#### ADDENDUM NO. 1 TO PROJECT NO. 44975

#### CONSTRUCTION, PLUMBING AND ELECTRICAL WORK REHABILITATE KITCHEN BUILDING No. 12 GOUVERNEUR CORRECTIONAL FACILITY SCOTCH SETTLEMENT ROAD GOUVERNEUR, NY

February 17, 2016

Image:
SHEET TITLE:
PHASE 2 - SIDE 'B' - REMOVALS ELECTRICAL
DRAWING NUMBER:
E-104

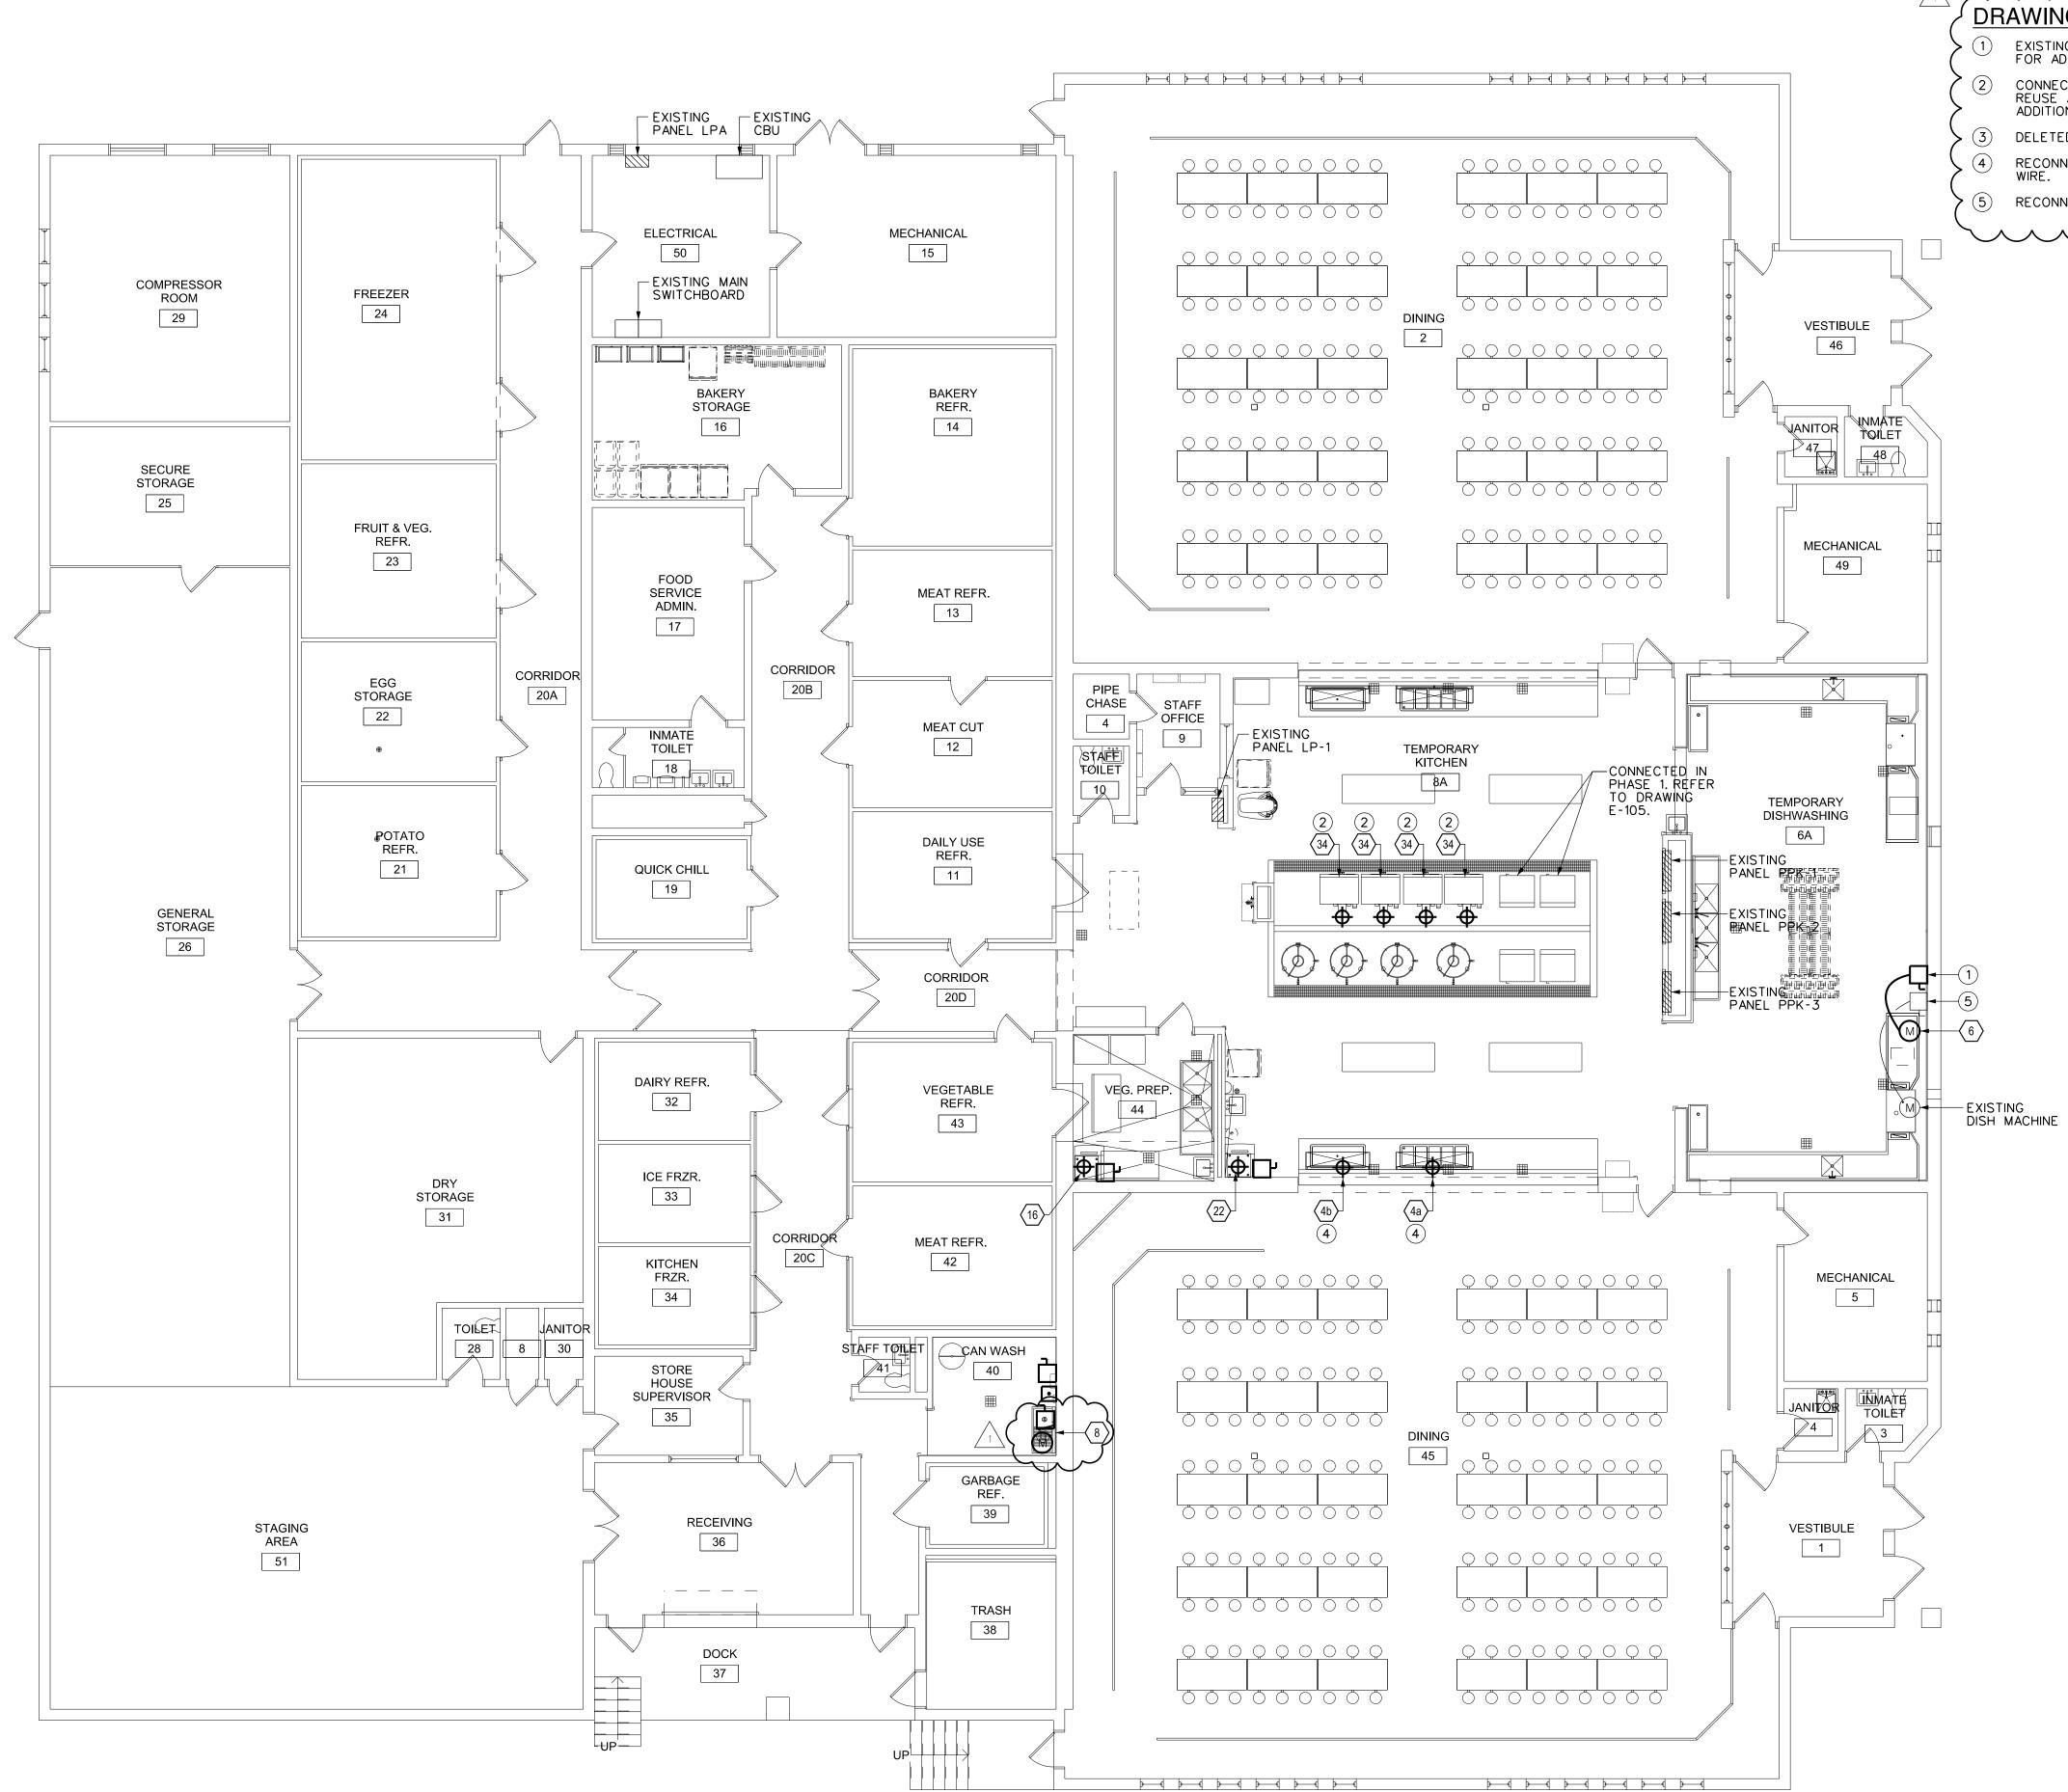
MOVAL NOTES: REMOVE EXISTING ELECTRICAL EQUIPMENT TO ACCOMMODATE CONSTRUCTION. EQUIPMENT TO BE REPLACED BY ITEM 8 IN RENOVATED KITCHEN. REFER TO DRAWINGS E-108 AND E-600.
2	DISCONNECT AND REMOVE EXISTING DISHWASHER AND BOOSTER HEATER TO ACCOMMODATE WALL, FLOOR AND CEILING CONSTRUCTION. TO BE REINSTALLED IN PHASE 2 REFER TO DRAWING E-108.
3	AFTER TEMPORARY KITCHEN AND DISHWASHING 8A IS FULLY FUNCTIONAL, DISCONNECT AND REMOVE ALL EXISTING LIGHTING FIXTURES IN "KITCHEN 8B" AND "DISHWASHING 6B" TO ALLOW FOR CONSTRUCTION IN THIS AREA. MAINTAIN CONTINUITY OF CIRCUIT TO ALL FIXTURES AND SWITCHES THAT ARE TO REMAIN DURING THIS PHASE OF CONSTRUCTION. FIELD VERIFY QUANTITIES AND LOCATIONS. COORDINATE WORK WITH PHASE 2 SIDE "A".
4	DISCONNECT AND REMOVE EXISTING DETECTOR. REINSTALL IN SAME LOCATION. REFER TO DRAWING E-107.
5	DISCONNECT EXISTING EQUIPMENT AT ELECTRICAL TROUGH. PROTECT CONDUIT AND CABLE DURING CONSTRUCTION. EXISTING CIRCUIT TO BE EXTENDED FOR TEMPORARY USE. REFER TO DRAWING E-105.

6	REMOVE EXISTING SKILLET AND ALL ASSOCIATED WIRE BACK TO PANEL PPK-2. EXISTING CONDUIT MAY BE REUSED WHERE FEASIBLE.
7	DISCONNECT EXISTING LIGHT SWITCHES TO ACCOMMODATE CONSTRUCTION.
8	REMOVE EXISTING RECEPTACLE AND ASSOCIATED CONDUCTORS BACK TO PANEL PPK-3. MARK BREAKER AS SPARE. REFER TO DRAWING E-108 AND E-600 FOR ADDITIONAL WORK.
9	DISCONNECT EXISTING SERVING LINE. EXISTING CIRCUIT SHALL BE REUSED FOR ITEM 4a AND 4b. REFER TO DRAWING E-108.
	REMOVE EXISTING MIXER AND ALL ASSOCIATED CONDUIT
	DAMAGED CONDUIT IN SLAB TO BE REPLACED. REMOVE CONDUIT FROM DAMAGE POINT BACK TO PULL STATION ON EAST WALL. REPLACE CONDUIT AND REINSTALL EXISTING CABLE. NO SPLICES IN EXISTING CABLES ARE PERMITTED. PROVIDE ALL THREADED FITTINGS REQUIRED FOR A COMPLETE CONDUIT SYSTEM FROM END TO END.

SHEET 25 OF 49	drawing number: Q-106	SHEET TITLE: PHASE 2 - SIDE "B" FOODSERVICE EQUIPMENT	APPROVED: AEG	FIELD CHECK:	DRAWN BY: CY	DESIGNED BY: CY	PROJECT 44975 - (	MARK DATE DESC	05/18/2015 BID	△ 02/17/2016 REVI:				
	)6	SIDE "B" RVICE ENT						DESC RIPTION	BID DOCUMENTS	REVISED DRAWINGS

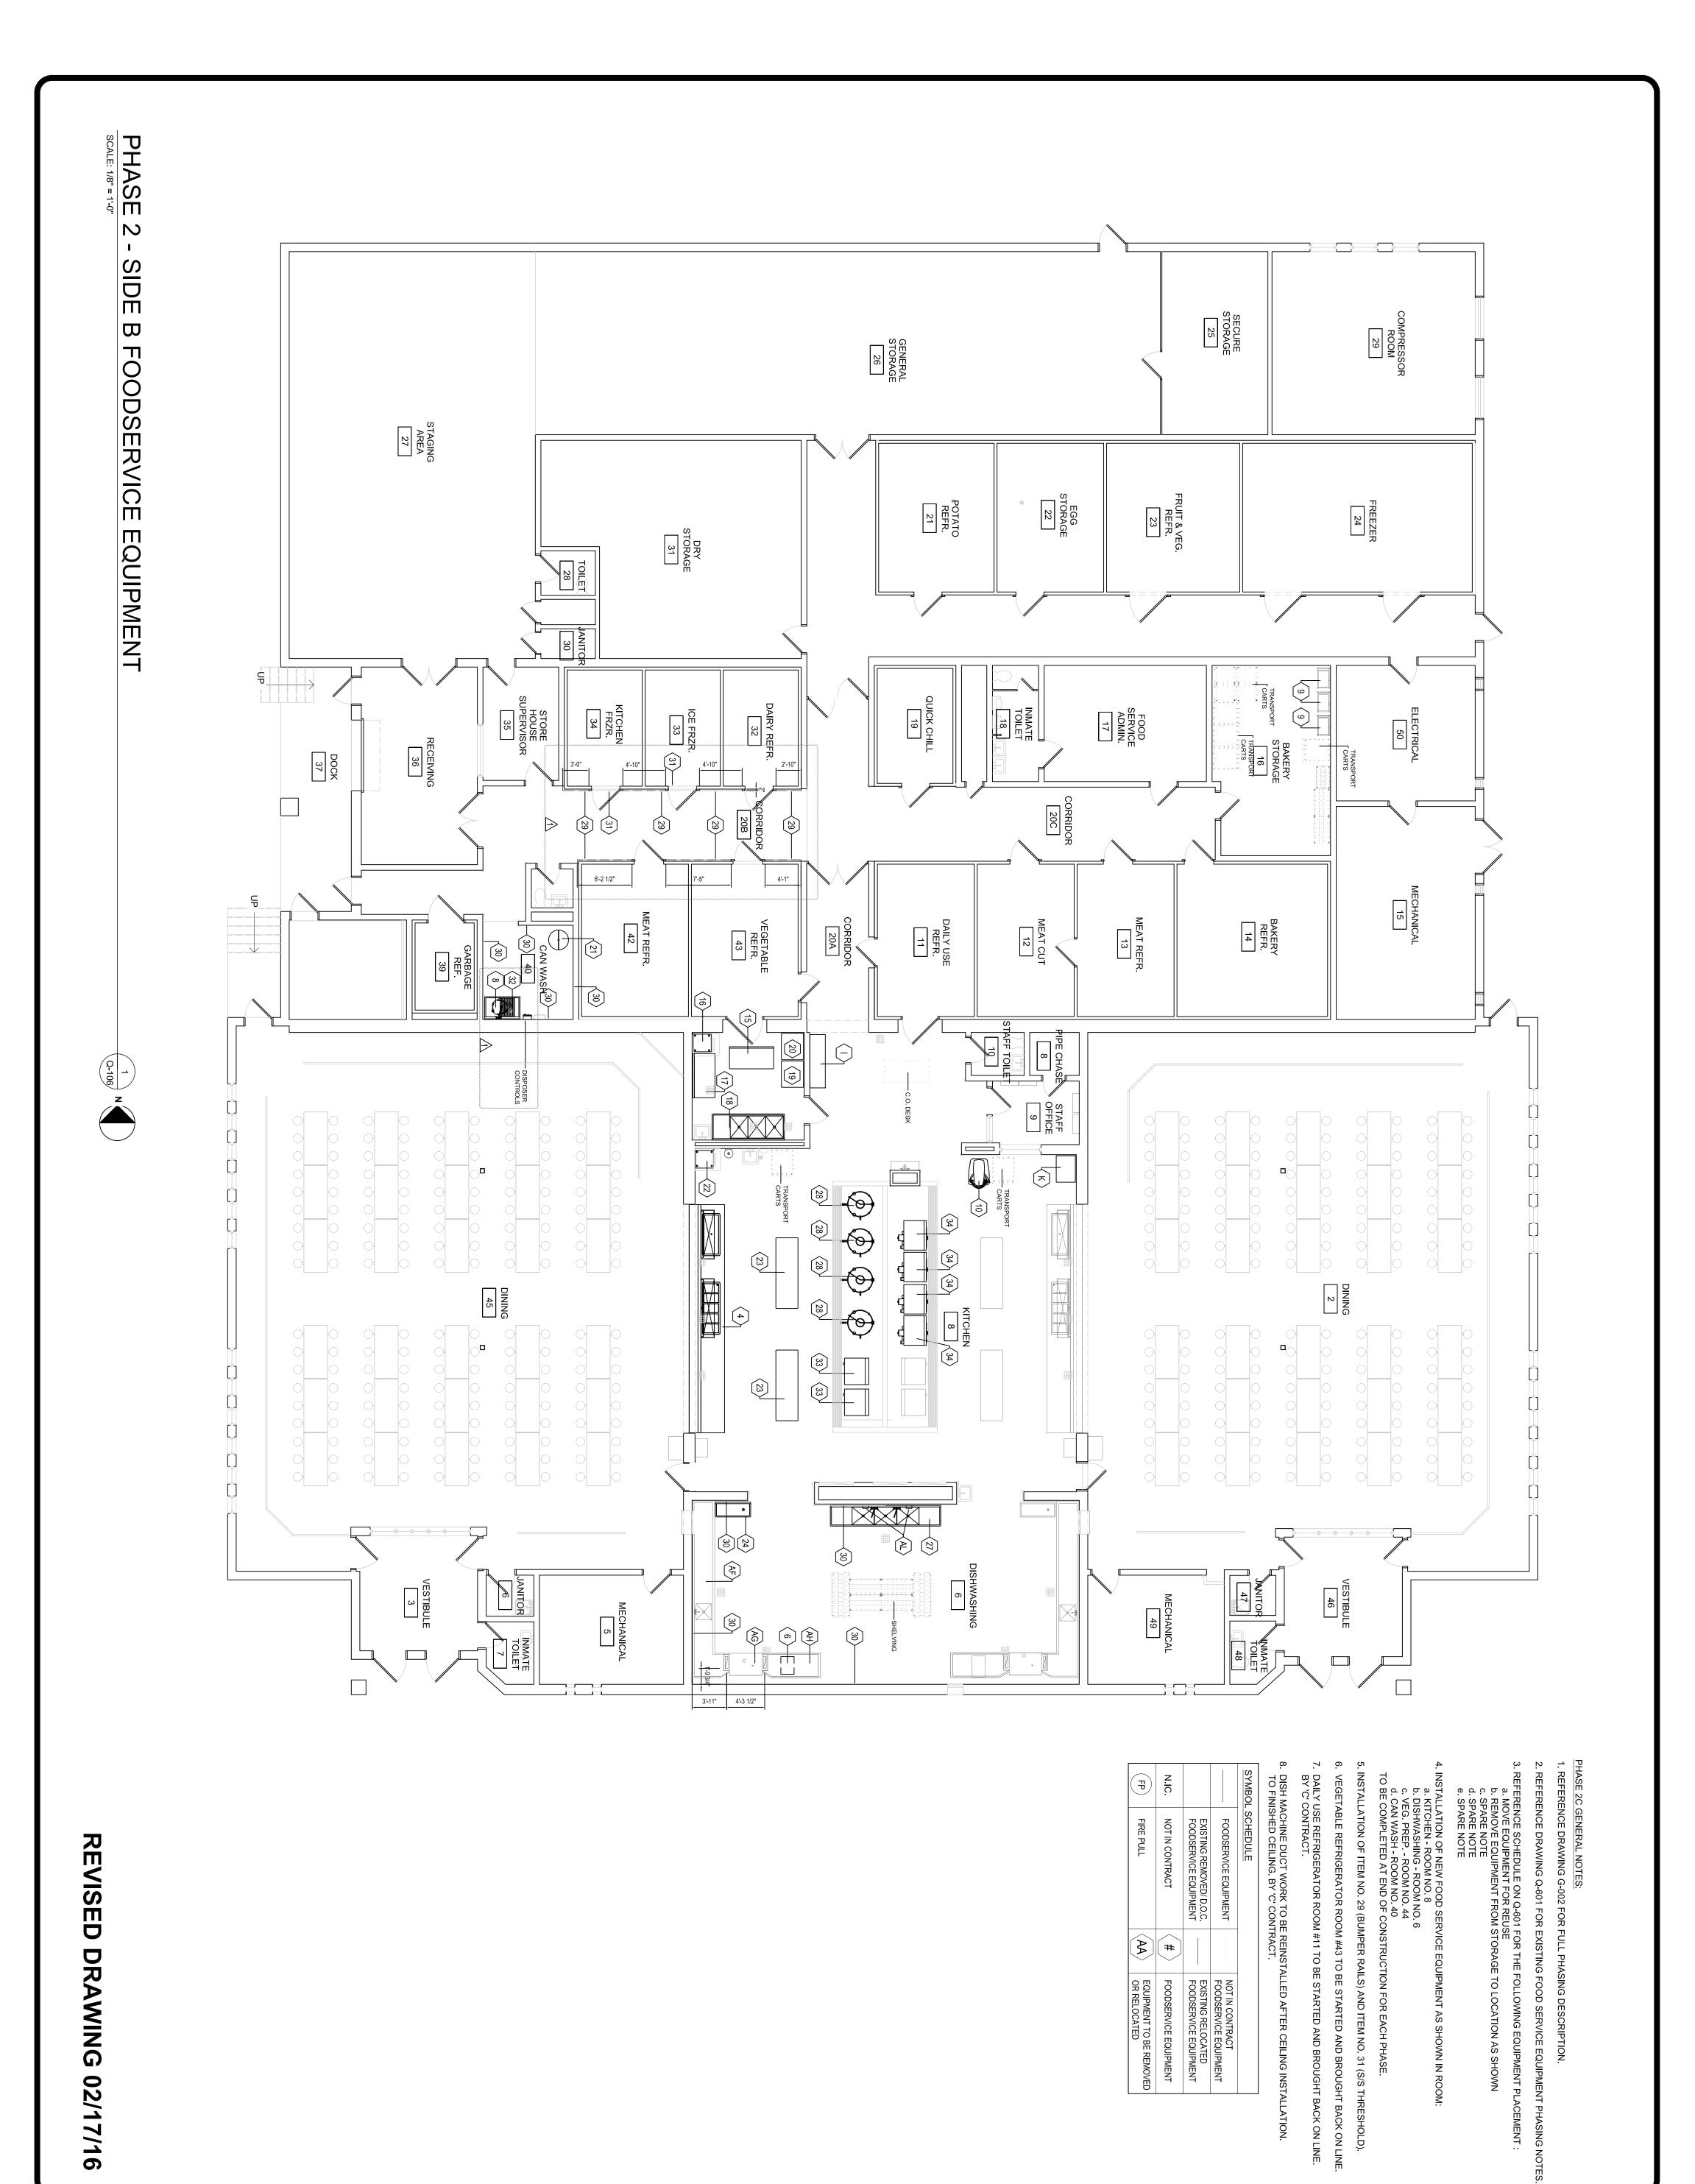
- "B. Size 4'-0"x 30" x 36" working height, Configuration per Revised Drawing Nos. Q-106 and Q-502.
- 6. Page 114102-3, Subparagraph 2.01 F.1.: Delete this Subparagraph in its entirety.
